Service Bulletin No: 35-002

Modification No: EC-10-0019

**OXYGEN - ON-BOARD OXYGEN-GENERATING SYSTEM (OBOGS)
DO THE MODIFICATION TO THE OBOGS WARNING CONFIGURATION****1. Planning Information****A. Effectivity**

PC-21 aircraft MSN 103 thru MSN 108.

Wiring Diagram (Pre-Service Bulletin 35-002)
Figure 1

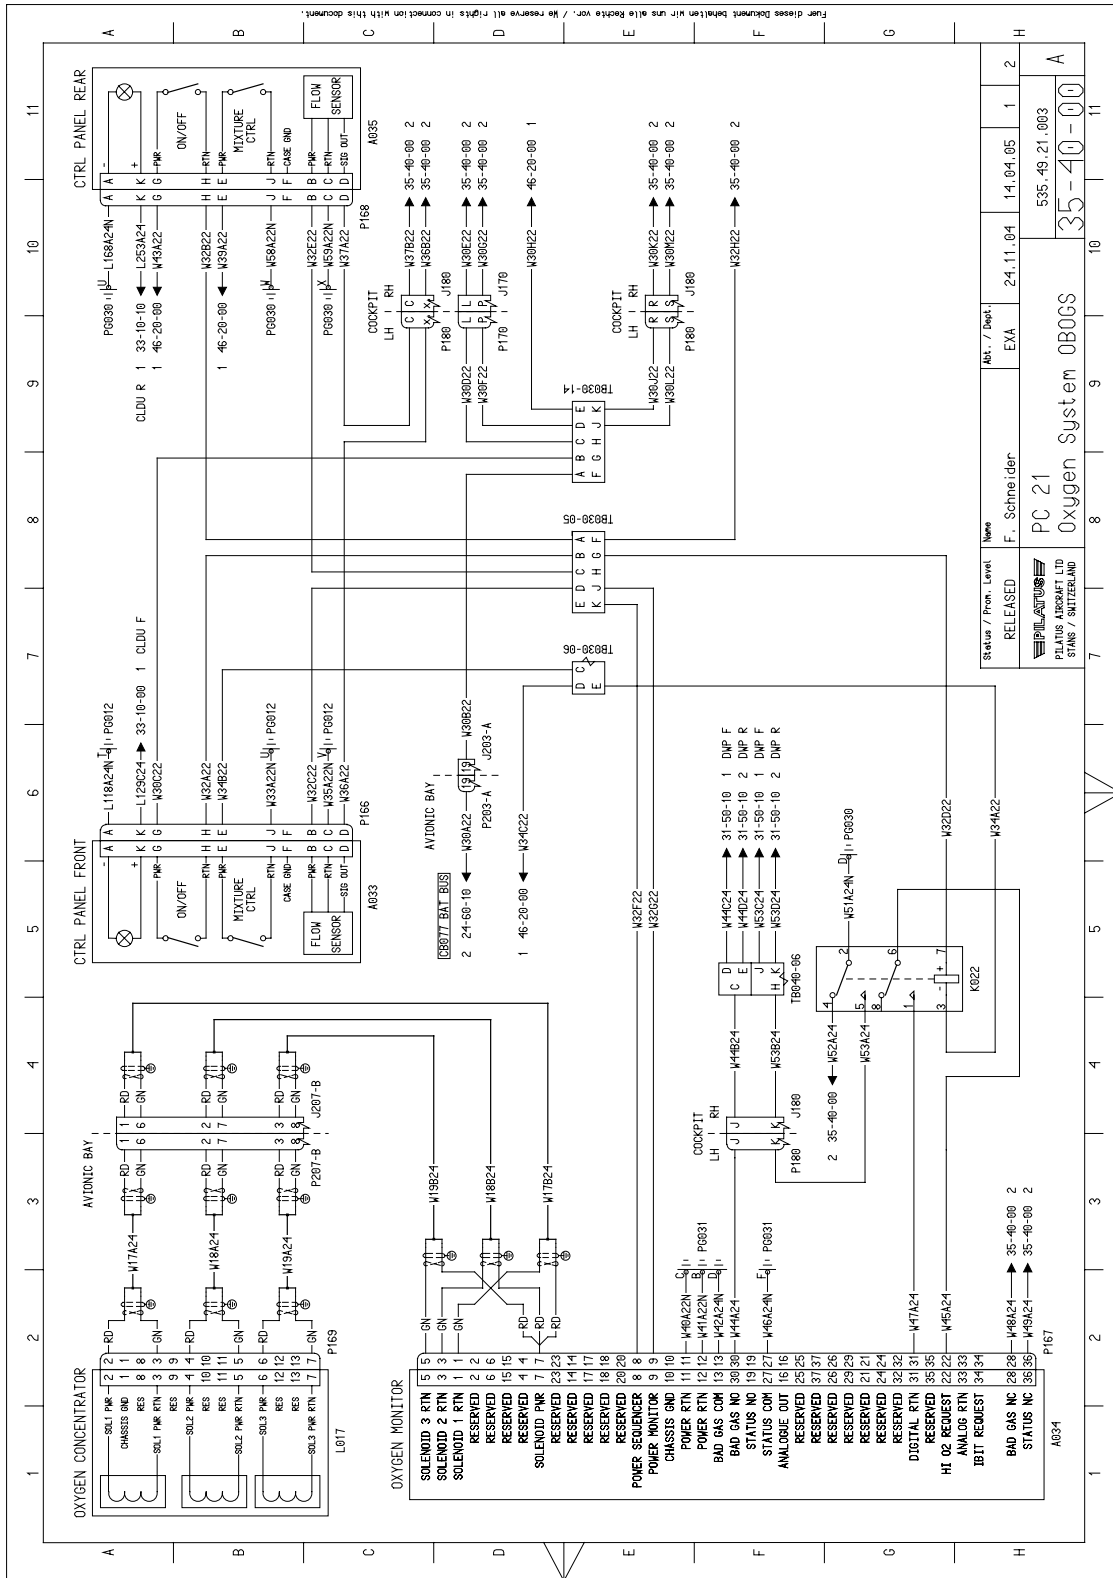
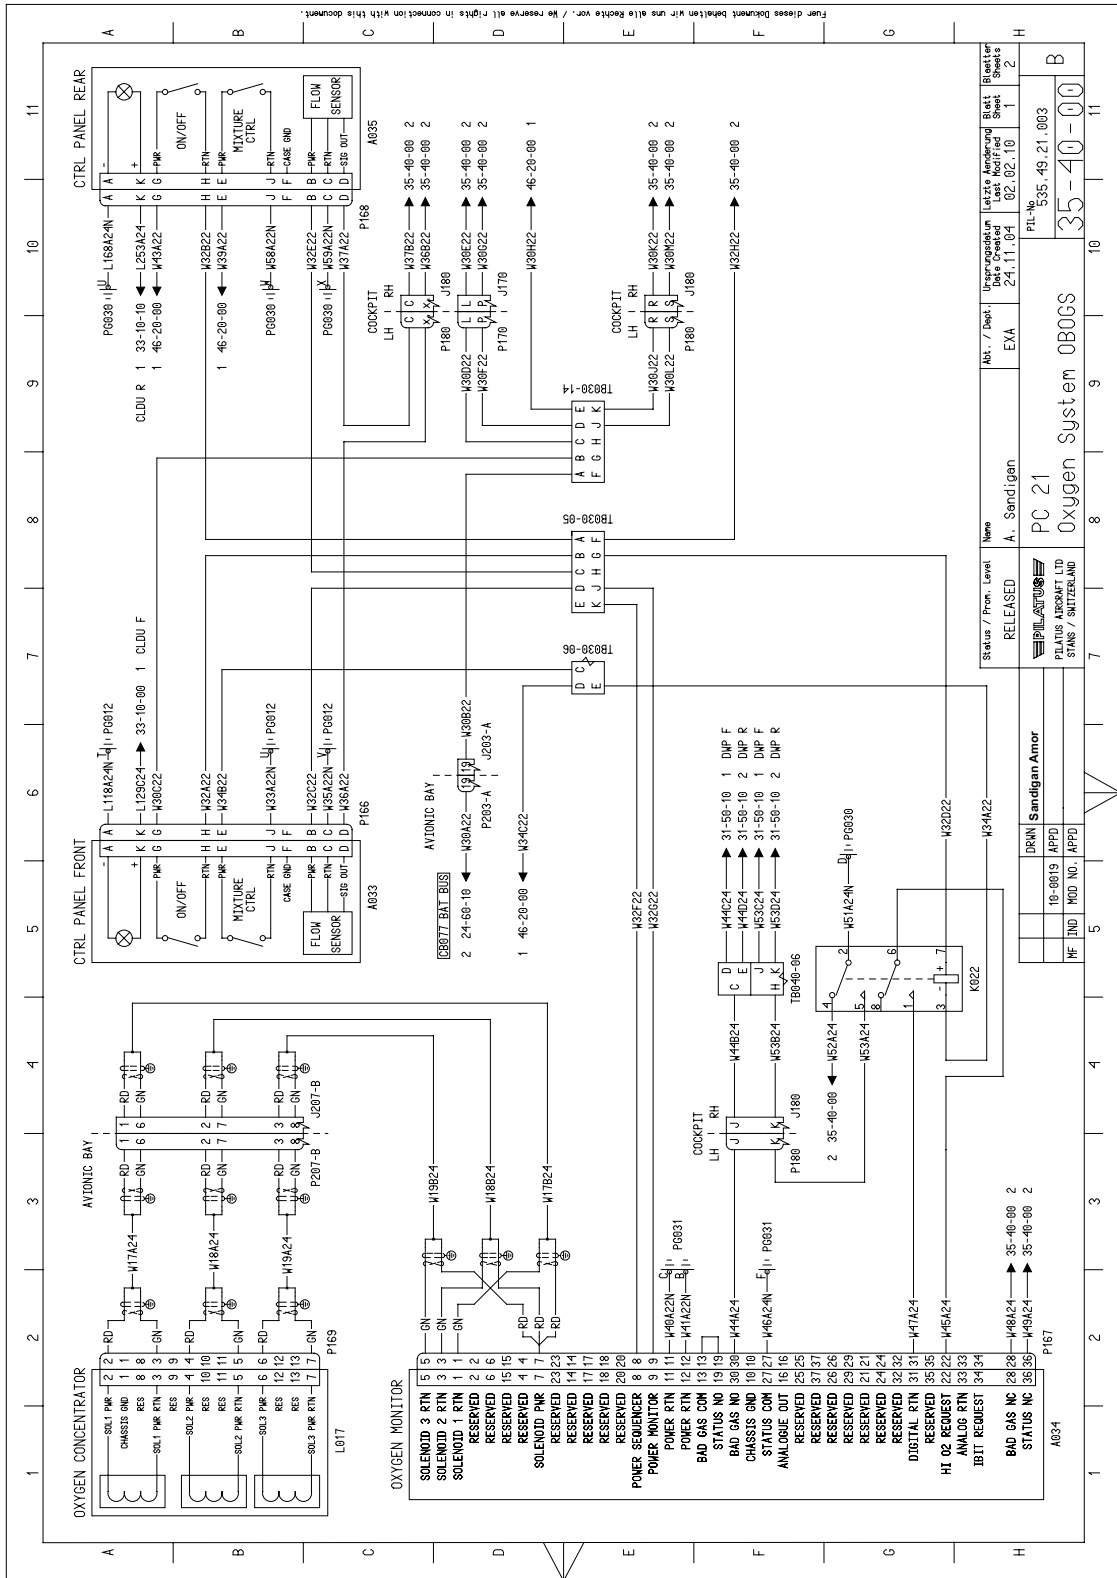
It has been discovered that not all BIT failures generate the correct warnings.

- Do a modification to the OBOGS wiring in the aircraft
- Update the Line Test Equipment (LTE)
- Update the control logic in all the RIOCs to make sure the BIT fail function is not only displayed as the red OBOGS symbol on the MFD, but also shows a red OXY warning on the MFD and the DWP.

- (1) Do the modification to the aircraft wiring:
 - (a) Disconnect and remove the wire W42A24N from between terminal 13 of the electrical connector P167 and terminal D of the electrical ground PG031 located in the rear cockpit on the left side (Ref. Hook-Up Chart, Fig. 3, Line 1).
 - (b) Install the jumper wire (Ref. Hook-Up Chart, Fig. 3, Line 2)
 - 1 Install a pin (P/N 971.75.17.903) on one end of the new wire (P/N 919.79.41.301).
 - 2 Connect the wire to terminal 13 of the electrical connector P167.
 - 3 Route the wire to terminal 19 of the electrical connector P167 and cut to length.
 - 4 Remove the pin from terminal 19 of the electrical connector P167.
 - 5 Install the pin from terminal 19 on the other end of the new wire (P/N 919.79.41.301).
 - 6 Connect the wire to terminal 19 of the electrical connector P167.
- (2) Do the procedure to install the LTE Configuration Files

Line	End 1			Wire No.	Color	End 2			Remarks	
	Ident. No.	Terminal No.	Terminal P/N.			Terminal P/N.	Terminal No.	Ident. No.		
1	P167	13	-	W42A24N	-	-	-	D	PG031	Disconnect Ends 1 and 2, remove wire
2	P167	13	971.75.17.903	Note 1	-	Note 2	Note 2	19	P167	New wire. Connect Ends 1 and 2
